**ZONING BOARD OF APPEALS APPLICATION FOR PUBLIC HEARING (VARIANCES, SPECIAL EXCEPTIONS, APPEALS OF ADMINISTRATIVE DECISIONS)**

Address: 828 S Stone Mountain Lithonia Rd City: Lithonia State: GA Zip: 30088

# Plan Review - Workflow Routing Slip

# Plan Review - Review Details

COVER SHEET &  
GEN. PROJECT  
INFO  
A0

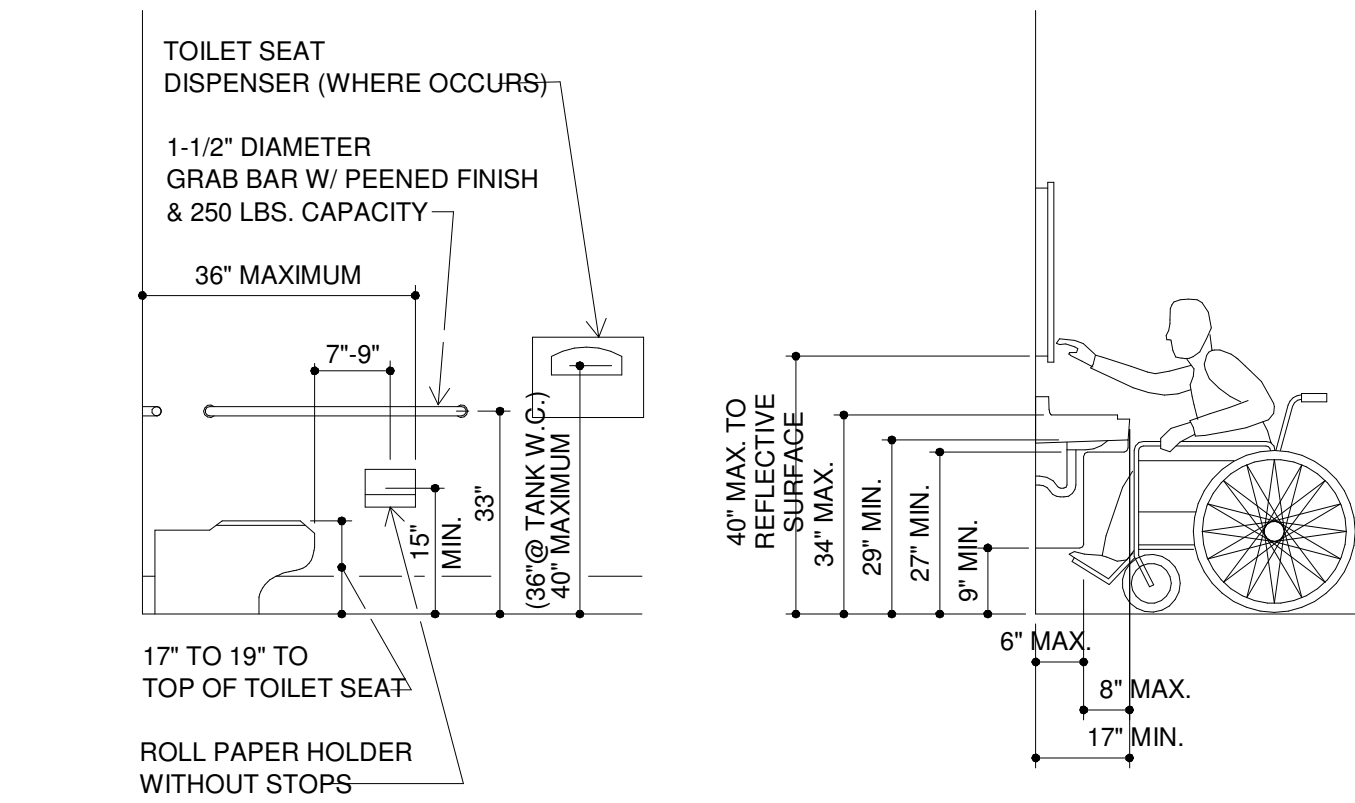
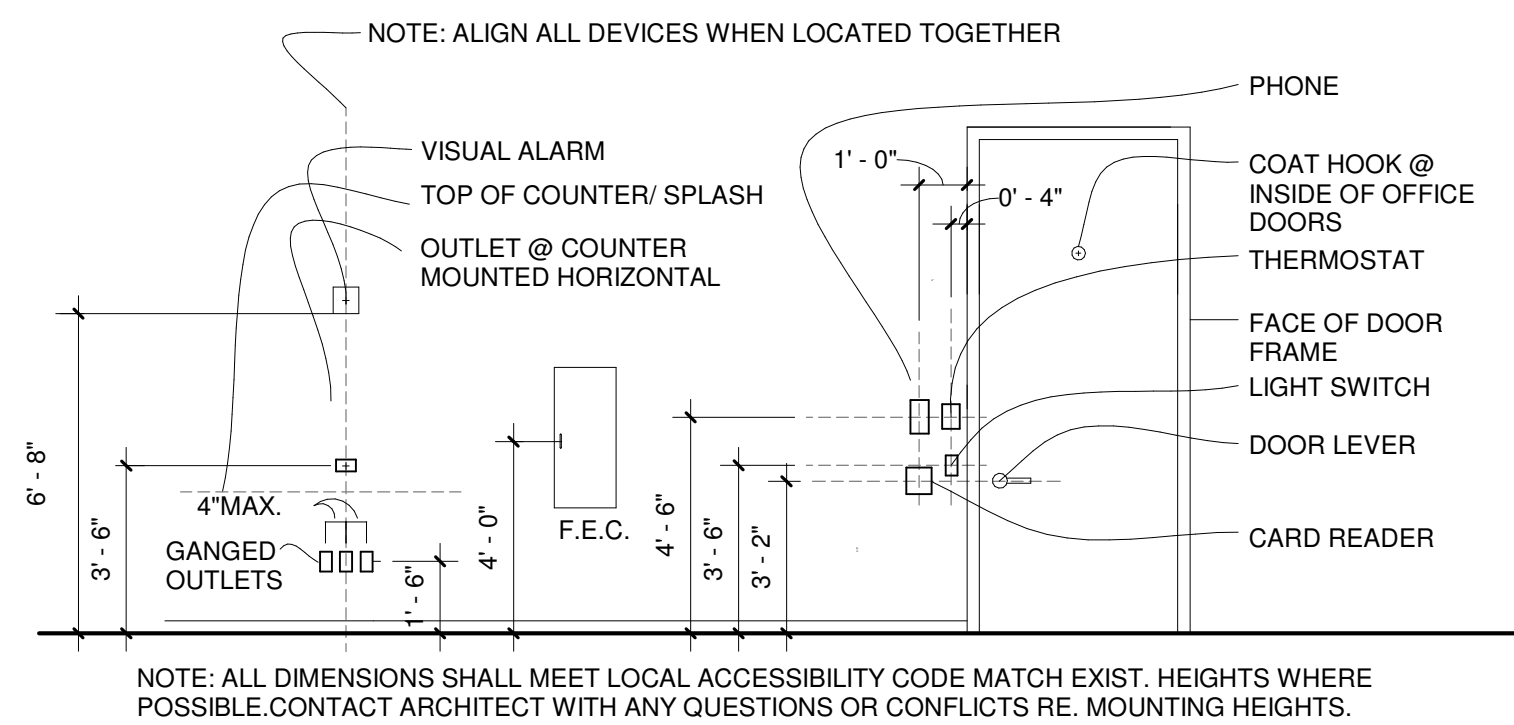
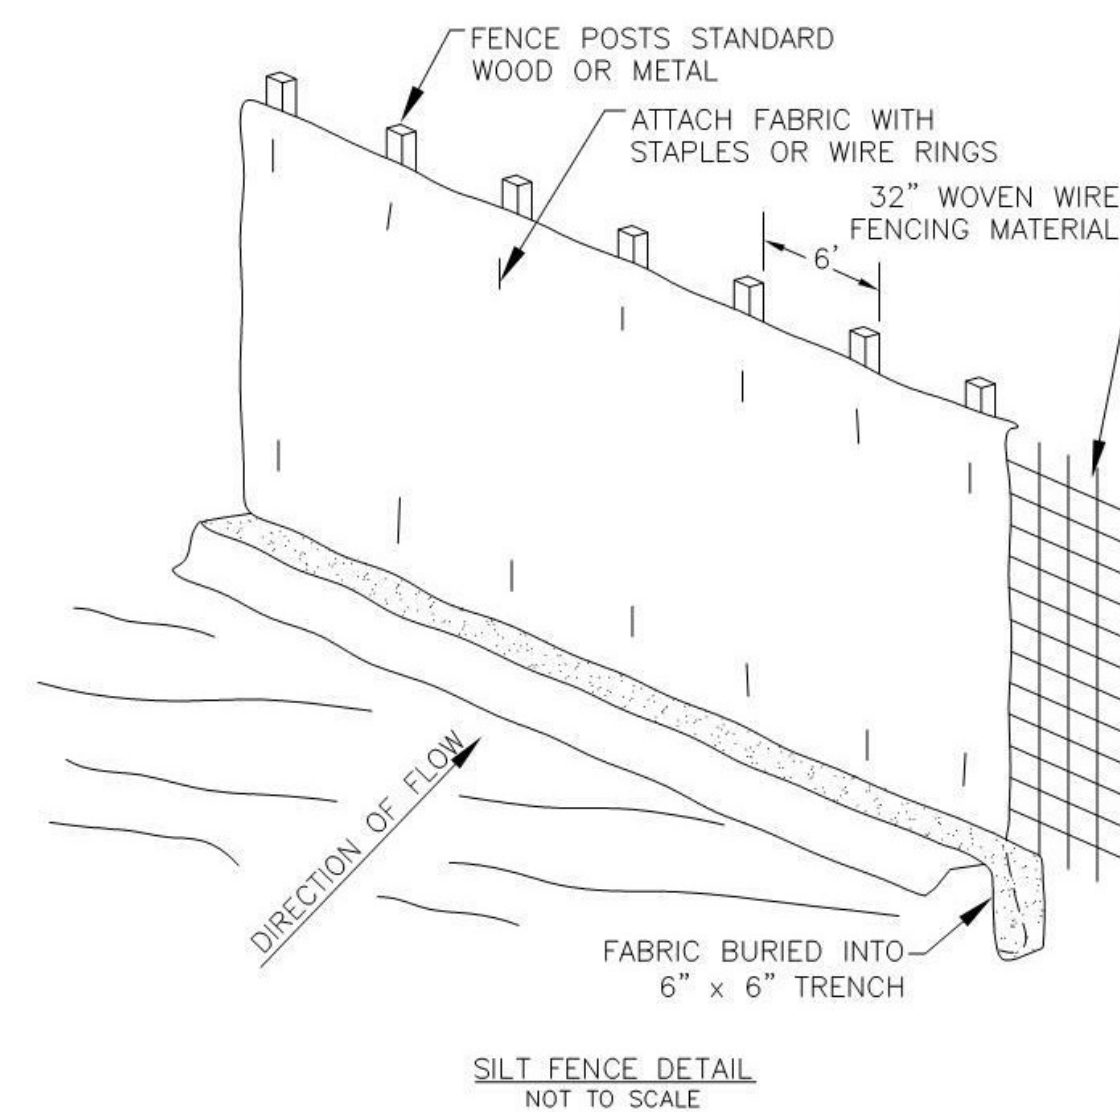
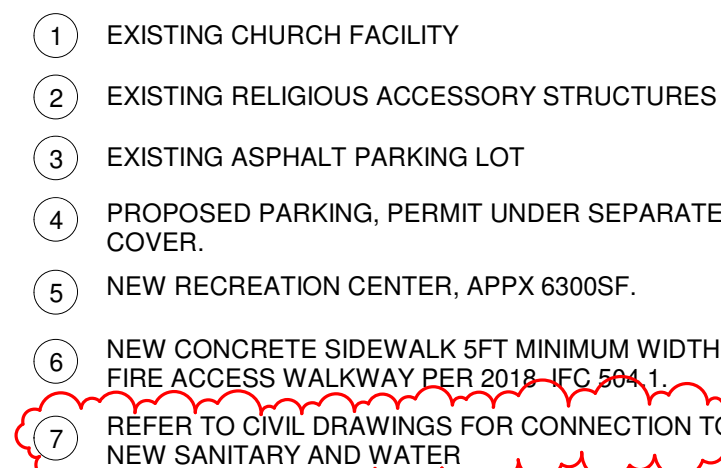
5	1	COMMERCIAL STRUCTURAL PLANS Tony Pruitt 11/14/23 3:51 PM	Changemark EXTINGUISHMENT PLEASE PROVIDE AND AUTOMATIC SPRINKLER SYSTEM FOR THIS FACILITY PER 2018 NFPA 101 SECTION 12.3.5.	A0 Cover Sheet.pdf	Responded by: Christopher TzegaegbE - 3/13/24 8:57 AM Revisions made	Resolved
6	1	COMMERCIAL STRUCTURAL PLANS Tony Pruitt 11/14/23 3:55 PM	Changemark APPLICABLE CODES PLEASE ADD THE FOLLOWING REFERENCE TO THIS LIST AND SHOW COMPLIANCE IN THE DESIGN ACCORDINGLY - SEE THE "BUILDING AND FIRE COMMERCIAL PLANS SUBMITTAL CHECKLIST" LOCATED IN THE DEKALB DOCUMENTS' FOLDER IN PROJECTDOX: Chapter 120-3-3 Rules and Regulations for the State Minimum Fire Standards in Georgia Link to Rules and Regulations:	A0 Cover Sheet.pdf	Responded by: Christopher TzegaegbE - 3/13/24 8:57 AM Revisions made	Resolved

48	3	COMMERCIAL STRUCTURAL PLANS Tony Pruitt 4/18/24 5:29 PM	Changemark RISK CATEGORY BECAUSE OF THE PROPOSE ASSEMBLY OCCUPANT LOAD IS IN EXCESS OF 300 PERSONS AS INDICATED ON SHEET A0, PLEASE DESIGN THE PEMB TO RISK CATEGORY III INSTEAD OF II.	A6 V3.pdf	Responded by: Christopher TzegaegbE - 6/25/24 11:00 AM Revision submitted	Resolved
